Re: **Planning Refusal 43797/APP/2022/1764** for 1a Bridge Way, Ickenham, UB10 8QR

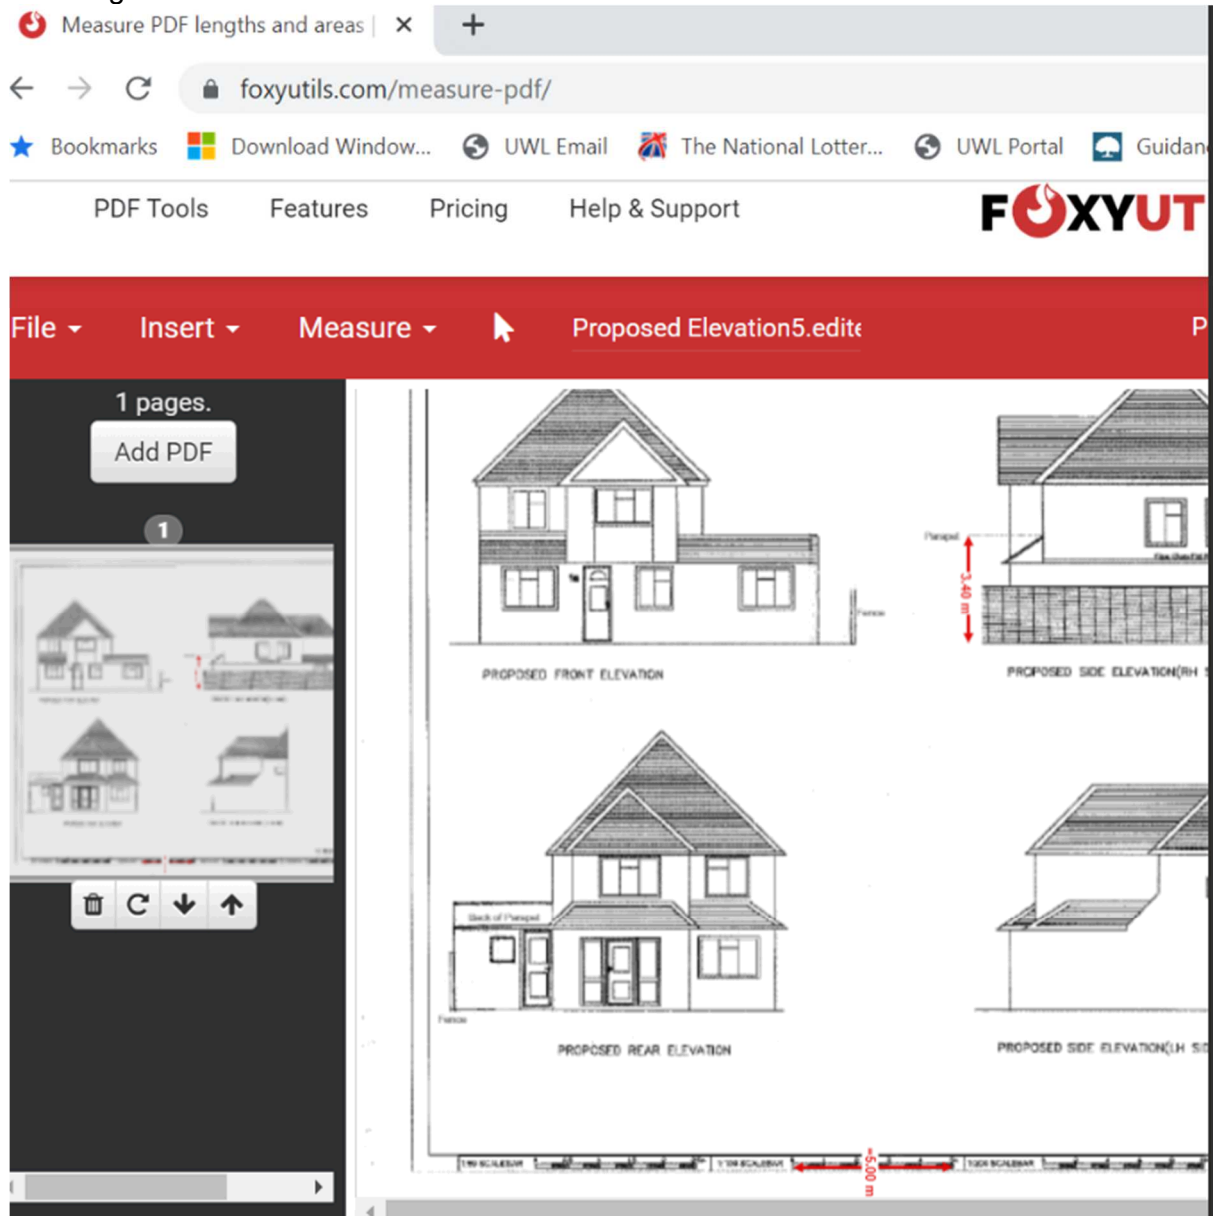
1 The proposed development does not constitute permitted development...because the proposed single storey side extension would extend beyond a wall which fronts a highway...

**Response:** There is a significant intervening area of land (consisting of hedge row and a separate wire fence) in different ownership between the boundary of the curtilage of the house and the highway.

The advice we followed was '(ii) the distance between the house and the highway - in cases where that distance is substantial, it is unlikely that a building can be said to front the highway. The same may be true where there is a significant intervening area of land in different ownership or use between the boundary of the curtilage of the house concerned and the highway' (**page 16, 190910\_Tech\_Guide\_for\_publishing.pdf**)
